SEISMIC MARGINS STUDY  
J. Kovic needs to review the portions of Attachment 2  
relative to UNITED STATES geotechnical engineering

NOTE FOR: George Lear, Chief SGEB  
THRU: P. T. Kuo, Section Leader, Section B, SGEB  
FROM: Frank Rinaldi, Structural Engineer, Section B, SGEB  
SUBJECT: MEETING SUMMARY - TERA's IDCVP

Re: Docket Nos. 50-329 OM, OL and 50-330 OM, OL  
Midland Nuclear Plant - Units 1 and 2  
Independent Design and Construction Verification (IDCV) Program  
Meeting Summary

130.30 With respect to Volume II, Seismic Margin Review: Reactor Containment Building, forwarded by your letter of March 30, 1983, provide the following information:

FIGURE Q&R 130.30.1-1 ENVELOPED SRSS COMBINED RESPONSE SPECTRA REACTOR BUILDING, INTERNAL STRUCTURE, ELEVATION 626'-0", NORTH-SOUTH DIRECTION, 2% CRITICAL DAMPING

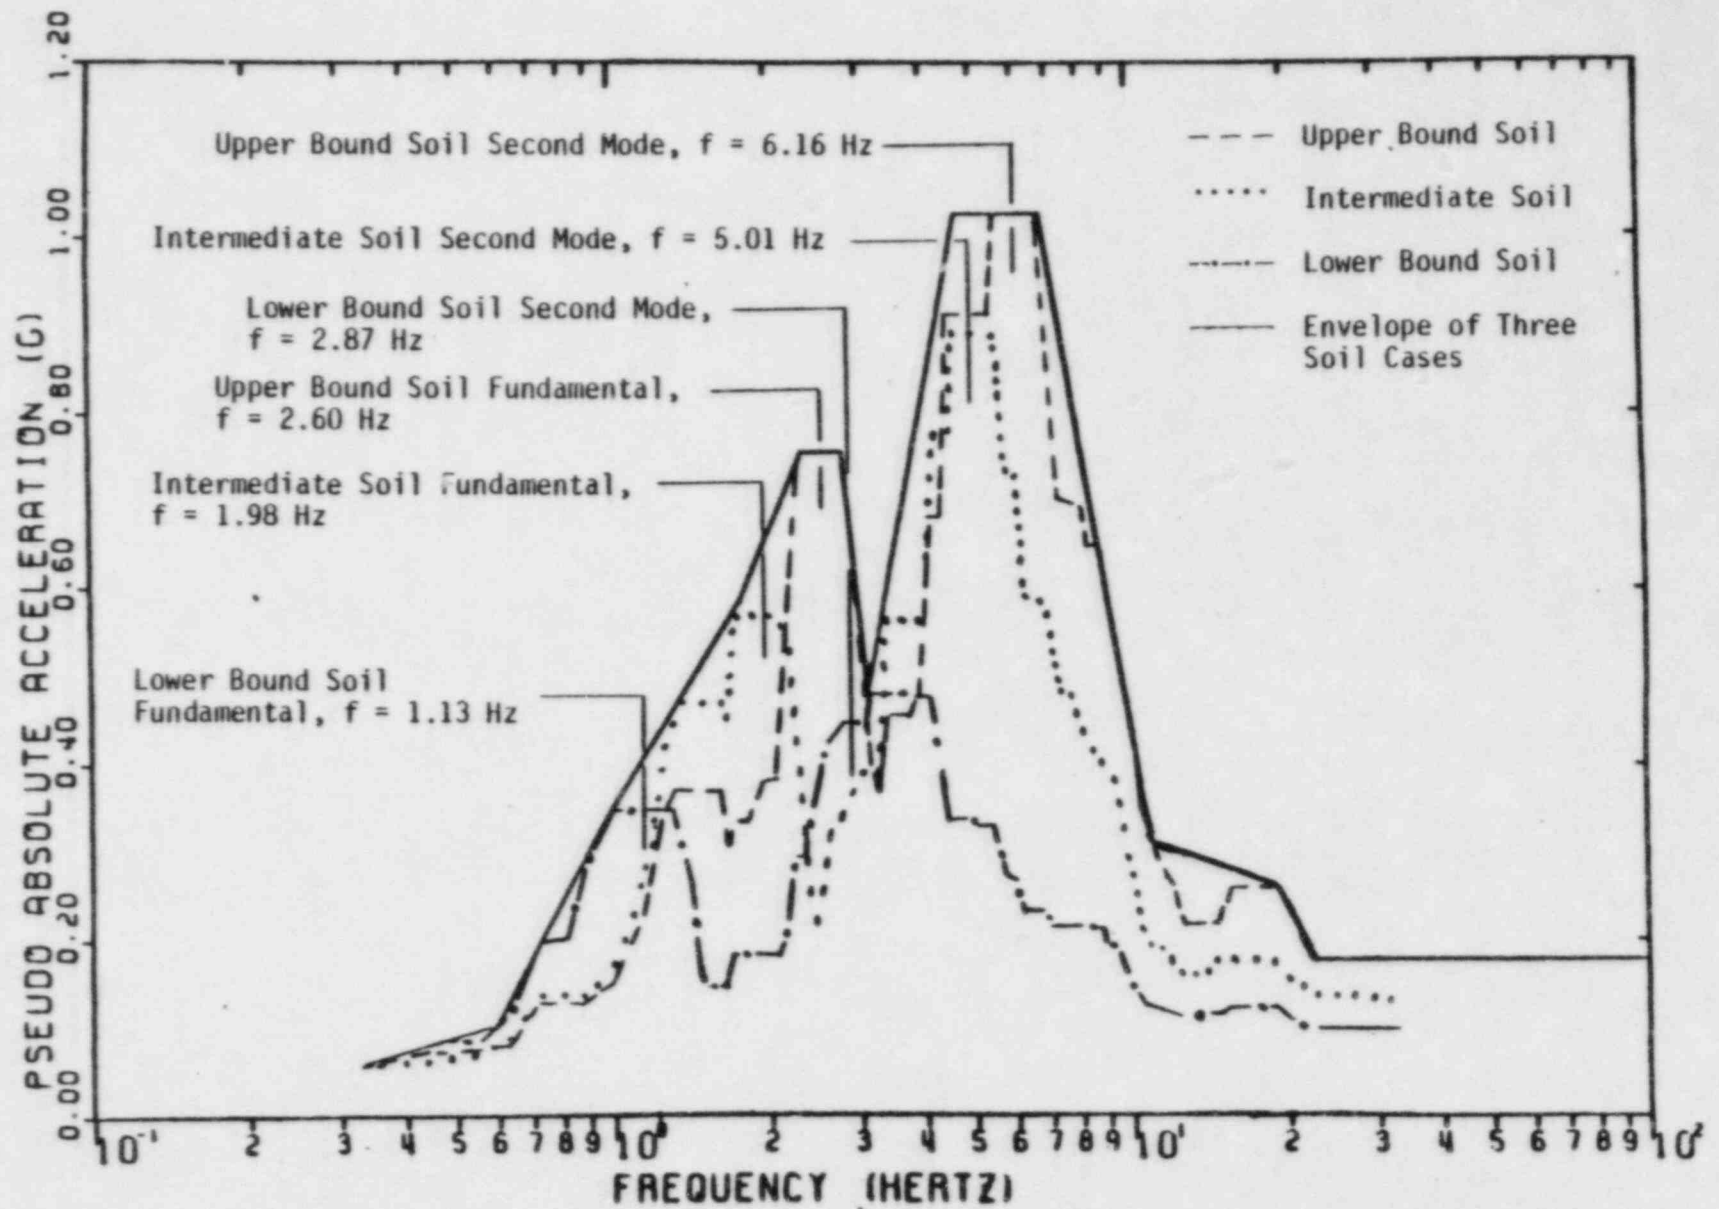
Question 130.30.1 The response spectra in Figures II-5-3 through 6, -10 through -22, -24, -27, -30, -33, -36 and -39 show the valleys. This does not seem consistent with the previously made statement that the peaks of three soil stiffnesses would be connected so as to eliminate valleys and, therefore, cover possible intermediate soil stiffnesses. Please discuss this inconsistency.

Response: The final Seismic Margin Earthquake (SME) in-structure response spectra were developed as an envelope of the broadened spectra for the different soil cases at each location as discussed in Section 8 of Volume I. This development of the enveloped spectra considered possible shifting of structure frequencies due to uncertainty in actual site soil conditions. The enveloped spectra were further smoothed to remove minor valleys.

The procedure used to develop the in-structure response spectra can be demonstrated by the example in the attached Figure Q&R 130.30.1-1. This figure forms the basis for Figure II-5-4 for 2 percent of critical damping and is similar to all the questioned response spectra curves. The three dashed lines in the figure correspond to the in-structure response spectra generated for the lower bound, intermediate, and upper bound soil cases. These

spectra already include a peak broadening of  $\pm 1.10f_j$  on structure mode  $j$  having frequency  $f_j$ . The solid line surrounding the dashed line spectra represents an envelope of the results for the three soil cases studied that accounts for possible variations in structure frequencies.

The first peak in the final enveloped spectrum accounts for the possible variation in the fundamental reactor building frequency. These frequencies are presented in Table II-3-2 of Volume II and range from a low of 1.13 Hz for the lower bound soil case to a high of 2.60 Hz for the upper bound soil case. The second peak in this spectrum accounts for possible variation in the second mode response of the structure. Frequencies for this mode range from 2.37 Hz for the lower bound soil case to 6.16 Hz for the upper bound soil case. The valley between the two peaks represents a region where amplified reactor building structural response does not occur from either the fundamental or second mode for the range of soil conditions considered. Enveloped spectra at all locations on the reactor building were developed in a similar fashion.

FIGURE Q&R 130.30.2-1. Reactor Vessel Isolated Model

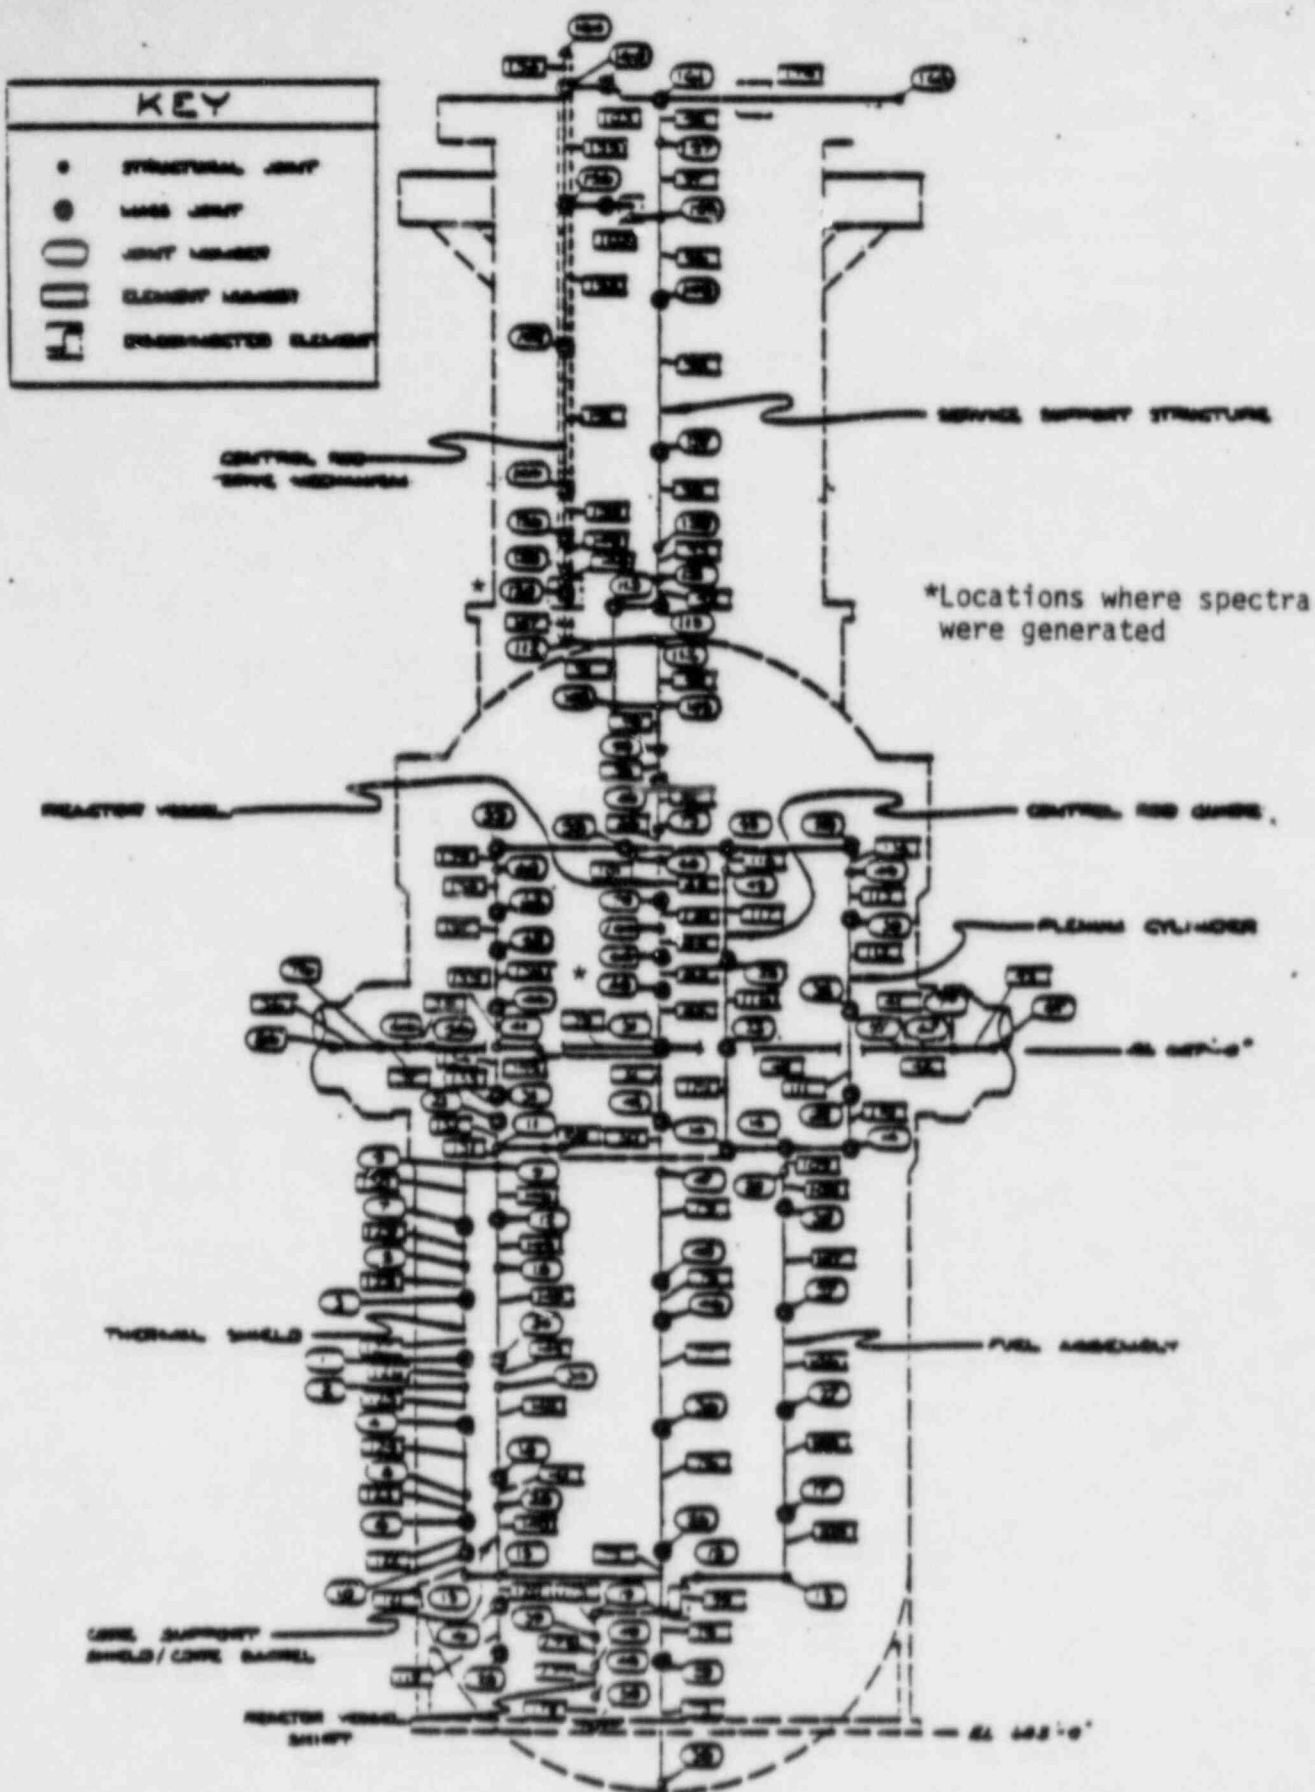
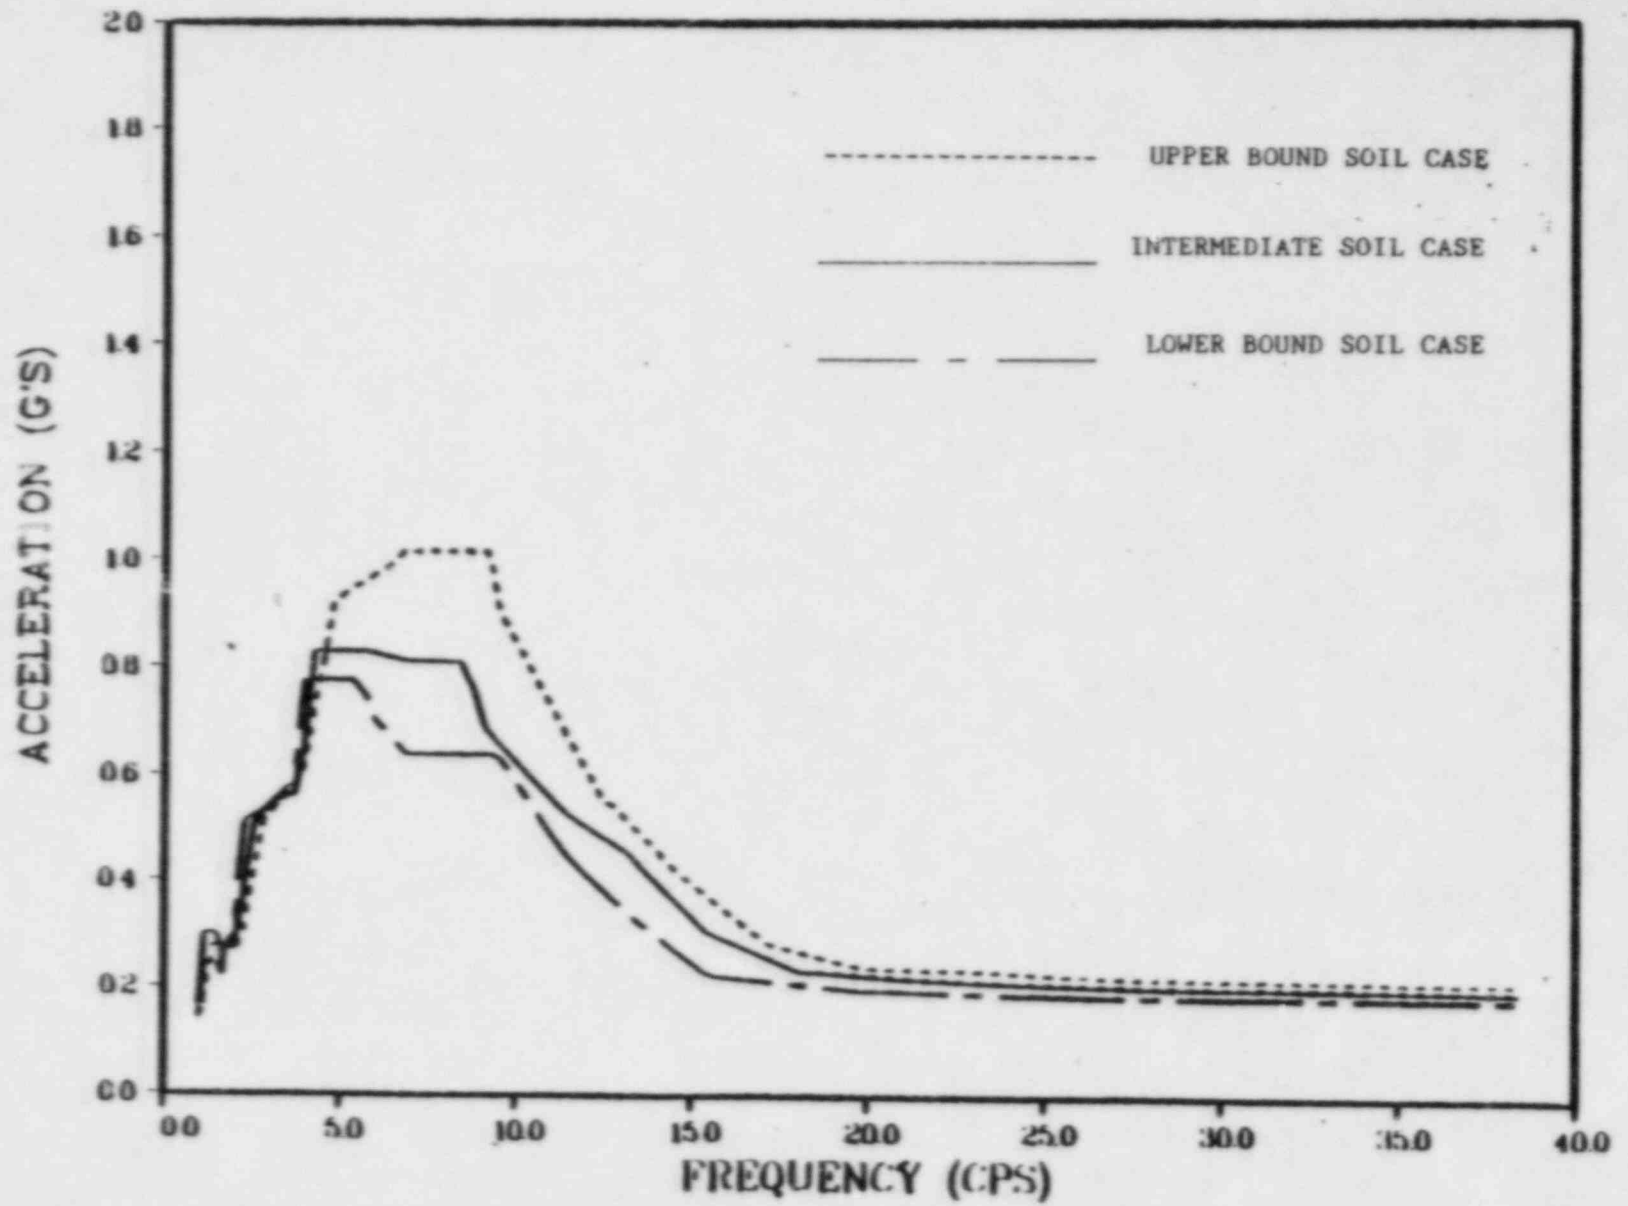
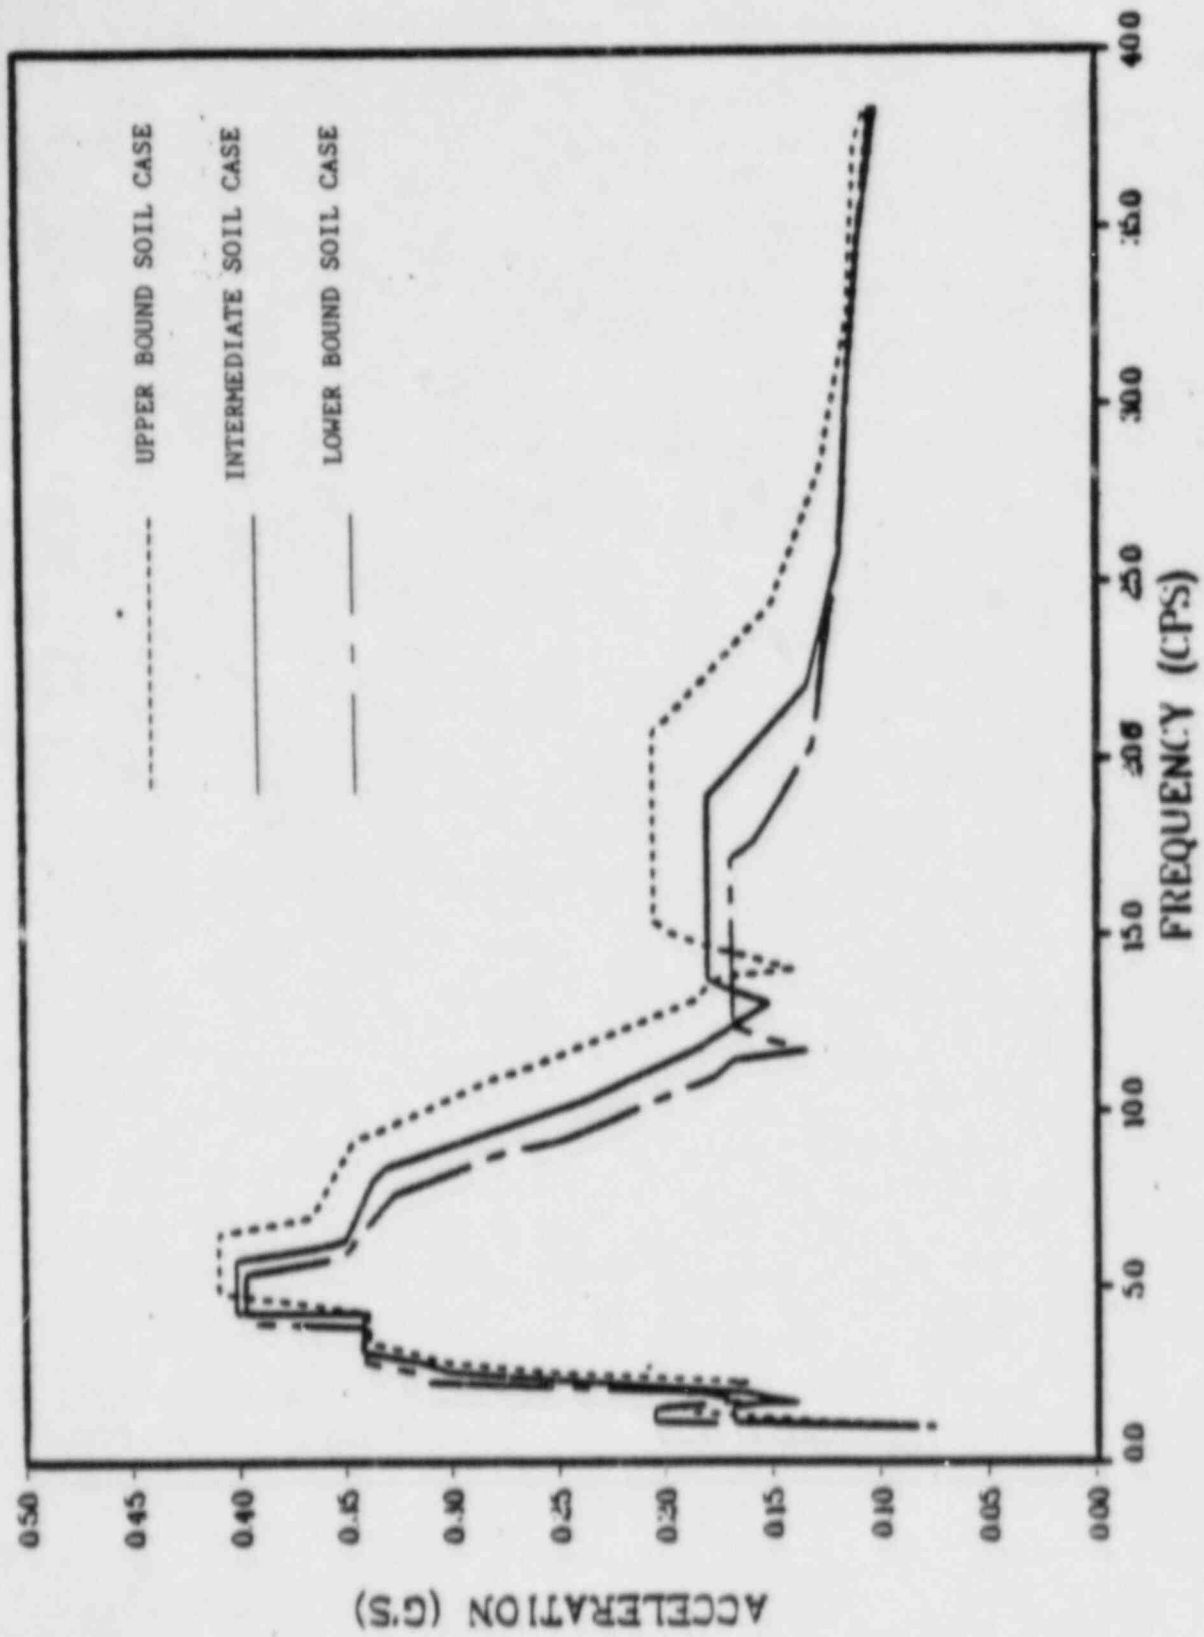
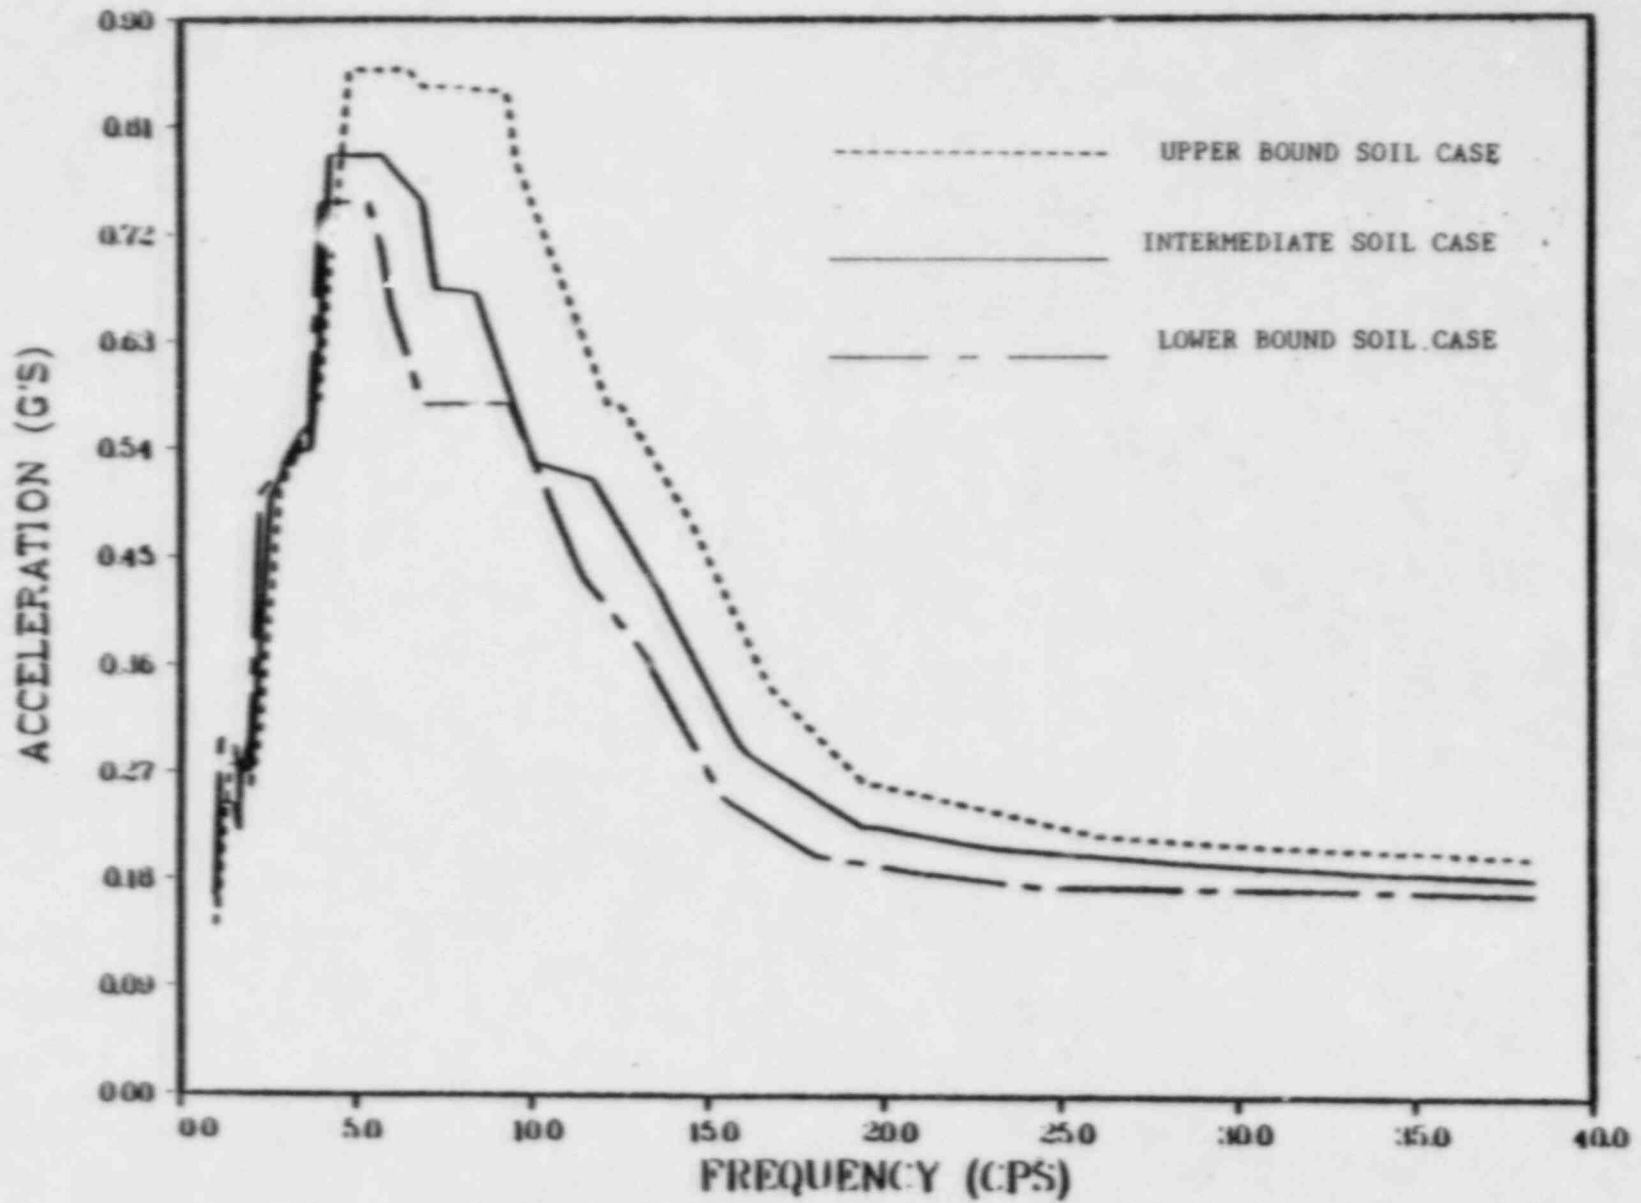
Section 5 of the report presents in-structure response spectra for internal structures. However, none are provided for the steam generators and the reactor vessel. Please provide these missing spectra or justify their omission.

Volume II was written to describe the analysis of the reactor containment buildings and their internal structures. In addition, Volume II presents the in-structure response spectra for use in evaluating equipment attached to the structure. Seismic input at the Nuclear Steam Supply System (NSSS) interfaces in the reactor containment buildings was developed by Structural Mechanics Associates, Inc. (SMA) for the Seismic Margin Earthquake. This input was defined in terms of translational and rotational time histories and response spectra for each of the three soil cases studied. The requested seismic response spectra were generated by Babcock & Wilcox (B&W), the NSSS Vendor. Since the B&W generated seismic response spectra are only an intermediate step in the Balance-of-Plant piping analysis, they were not included in Volume VIII. Figures Q&R 130.30.2-1 through Q&R 130.30.2-7 present the schematic of the reactor vessel model used by B&W and the seismic response spectra for 4 percent of critical damping. Similarly, Figures Q&R 130.30.2-8 through Q&R 130.30.2-17 are presented for the steam generators.
